Gilson BROTHERS COMPANY

Service Bulletin #85

SUBJECT: Gear Drive Snowthrowers Belt, Pulley, Chute Collar Idler Bracket Roll Pin, Wheel and Tire Corrections. Models 55012 - 55012A - 55017

FIG. 1

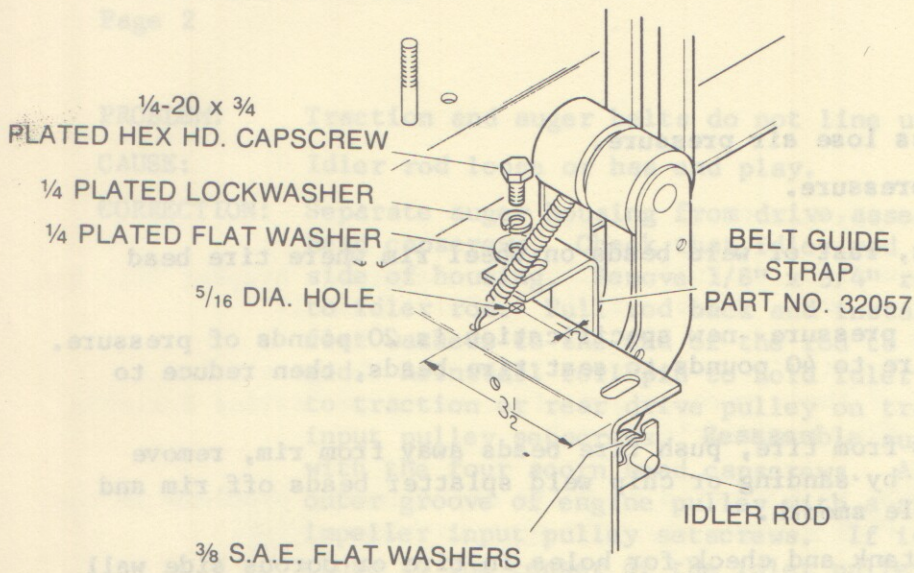
PROBLEM: Traction belt jumps off pulley or rolls over.

CAUSE: Idler pulley does not hold enough tension onto belt when snowthrower hits solid object like ice, solid frozen snow, or raised portion or uneven sidewalk.

CORRECTION: Install new belt guide stop #32057 to hold belt in pulley when shock load experienced.

1. Drill 5/16" hole in frame 1/2" from inside edge and 3 1/2" back from front edge of idler slot.
2. Engage traction clutch lever.
3. Attach belt guide strap--within 1/16" of belt and pulley--be sure guide is square with belt and belt is engaged. (See Fig. 1.)

FIG. 2

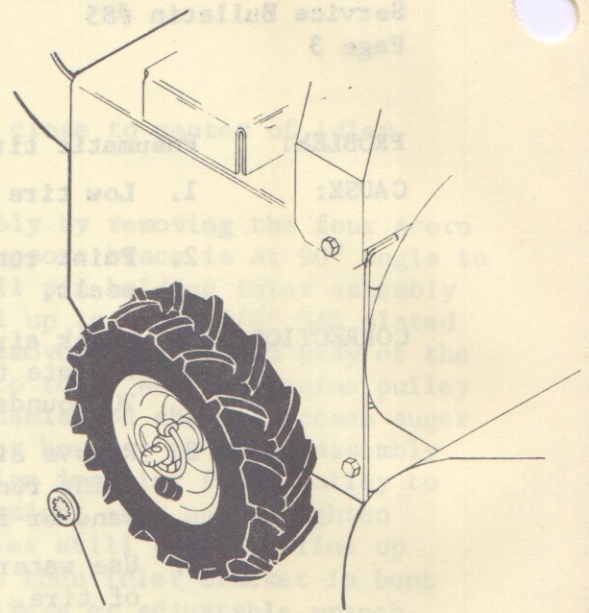
PROBLEM: Traction belt chewed up from chain riding belt.

- CAUSE:
1. Cotter pin on chain connecting link incorrectly positioned on belt side--remove cotter pin and connecting link reposition so cotter pin on frame side of chain.
 2. Wheels and klik pins incorrectly positioned in outer axle shaft hole for traction drive. As outlined in Owner's Manual and Service Bulletin #68 dated 12-28-72, wheels should drive in inner hole as outside hole is for free wheeling only.

CORRECTION: Install klik pins through wheel hole and inside hole of axle shaft; then push new retainer ring #32224 onto axle shaft until it is tight against wheel hub. This will prevent wheel from being pulled to outside hole for incorrect position for driving unit and causing premature belt failure. (See Fig. 2)

FIG. 3

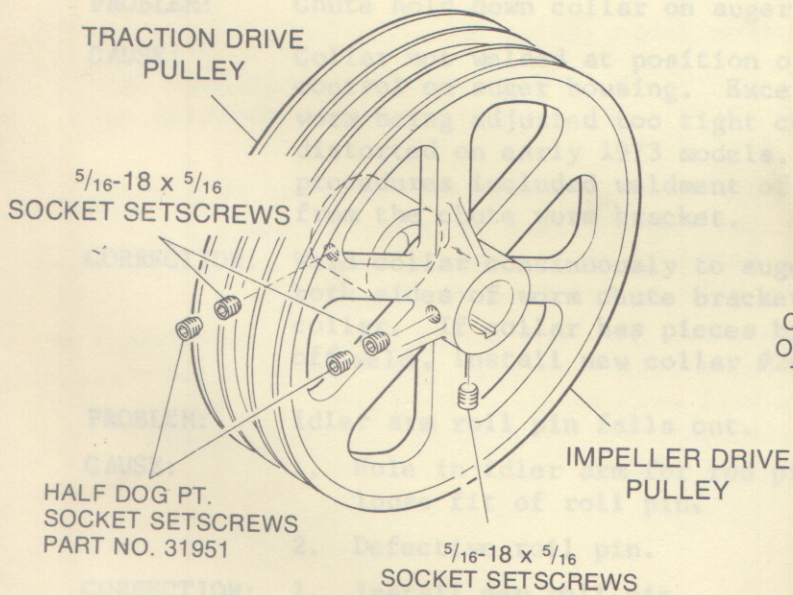
PROBLEM: Traction and impeller--pulley setscrews loosen up.

CAUSE: Setscrews not torqued tight enough or shock loads.

CORRECTION: Tighten setscrews to 140 inch pounds of torque and install a second or locking half dog point setscrew part #31951 in hole located 90° to keyway. A second setscrew can not be installed in keyway setscrew hole due to the thinner portions of the hub for the keyway. (See Fig. 3.)

FIG. 4

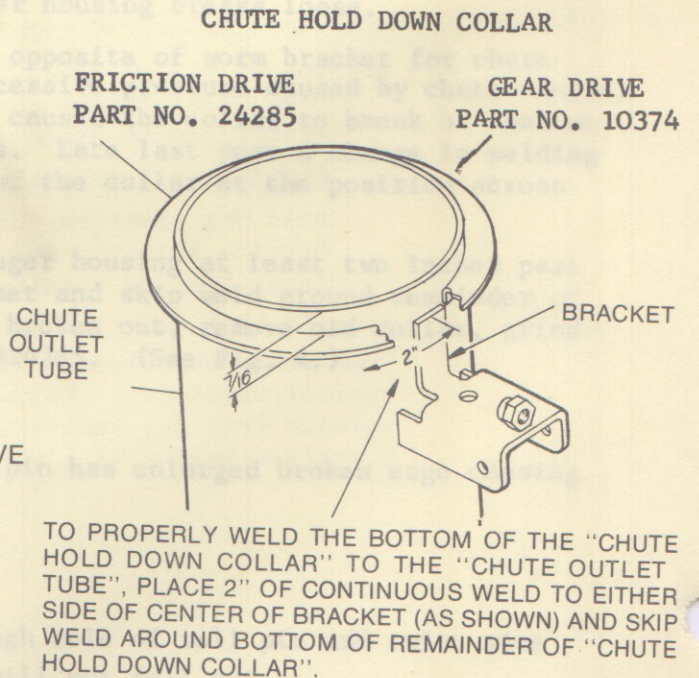
PROBLEM: Chute hold down collar on auger housing breaks loose.

CAUSE: Collar not welded at position opposite of worm bracket for chute control on auger housing. Excessive pressure caused by chute control worm being adjusted too tight caused the collar to break or become distorted on early 1973 models. Late last year a change in welding procedures included weldment of the collar at the position across from the chute worm bracket.

CORRECTION: Weld collar continuously to auger housing at least two inches past both sides of worm chute bracket and skip weld around remainder of collar. If collar has pieces broken out, remove old collar, grind off weld, install new collar #24285. (See Fig. 4.)
